UNITED STATES PATENT AND TRADEMARK OFFICE

APPLICATION NO.	FILING DATE	FIRST NAMED INVENTOR	ATTORNEY DOCKET NO.	CONFIRMATION NO.
09/455,991	12/06/1999	HISASHI OHTANI	07977/213002	5835

Office Action Summary

DETAILED ACTION

FIG. 8
(Prior Art)

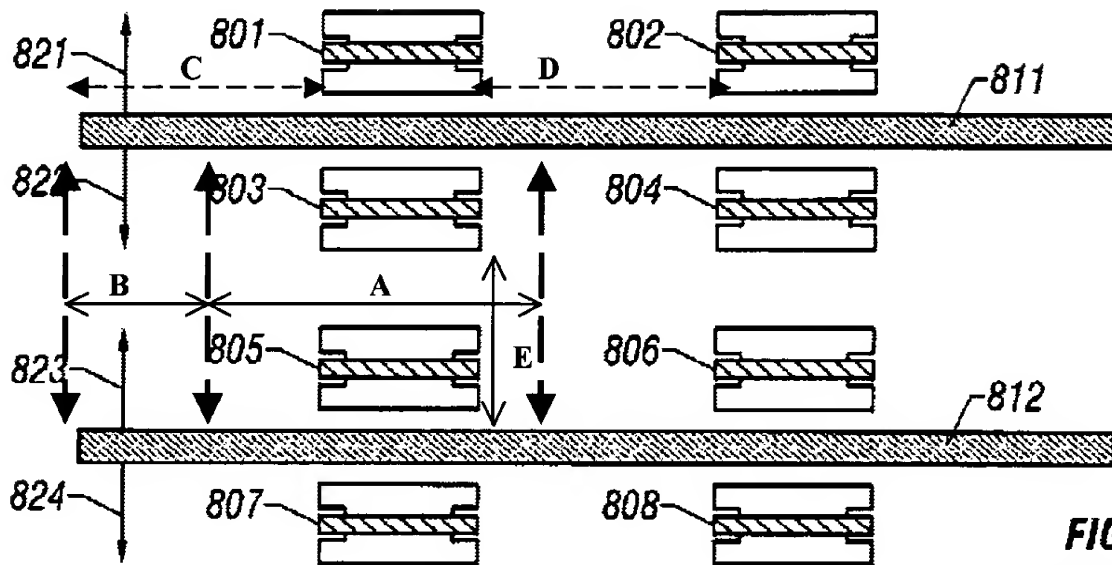
Regarding claims 6, 9, 23, 31, 39, 55, and 63, Applicant acknowledges a well-known method comprising the steps of: forming an amorphous semiconductor film (see page 1, lines 24-26) on an substrate (see page 1, lines 11-13); providing a metal element (811, 812) capable of promoting crystallization of the amorphous semiconductor film to form a first metal element added region (811) and a second metal element added region (812) (see fig. 8, below); crystallizing the amorphous semiconductor film so that a crystal growth (822, 823) proceeds in a crystal growth direction parallel to the insulating surface to form first and second crystalline portion (see regions A and B between the metal element 811 and 812 in Fig. 8, below); patterning the crystalline semiconductor film to form at least one crystalline island or active region (803) using only the first crystalline portion (see region A between the metal element 811 and 812 in Fig. 8, below); wherein the first metal element added region (811) is away from the second metal element added region (812); wherein carrier move in the crystalline semiconductor island (803) in a carrier moving direction identical

with the crystal growth direction (822, 823) (see page 4, lines 9-11 and fig. 8, below); wherein the second metal element added region (812) is located apart from the crystalline semiconductor island (803) by a distance (E) (see Fig. 8, below); wherein the first metal element added region (811) has a length extending longer from an end portion of the crystalline semiconductor island (803) in a longitudinal direction of the first metal element added region (consider the portion of the metal element (811) that is between the end side of the region (B) and the end side of the crystalline semiconductor island (803) in Fig. 8, below).

Regarding claims 7, 32 and 56, Applicant acknowledges that the lengths (C, D) of the first metal element added region (811) and the second element added region (812) are set to 50% or more of a crystal growth distance (please note that the regions C and D has a length which is about twice the length of 801 or 803 region, see Fig. 8, above).

Regarding claims 24, 40, 47-48, 64, and 71, applicant and Zhang et al., as stated before, teaches the claimed method (see rejection of claim 6, above). In addition, applicant acknowledges that the lengths (C, D) of the first metal element added region (811) and the second element added region (812) are set to 50% or more of a crystal growth distance (please note that the regions C and D has a length which is about twice the length of 801 or 803 region, see Fig. 8, above). With regards to the claimed length of 100 μm or more, it would have been obvious to one of ordinary skill in the art, since it has been held that where the general conditions of a claim are disclosed in the prior art, discovering the optimum or working ranges involves only routine skill in the art. *In re Huang*, 40 USPQ2d 1685,1688(Fed. Cir. 1996) citing *In re Aller*, 105 USPQ 233., 235 (CCPA 1955).
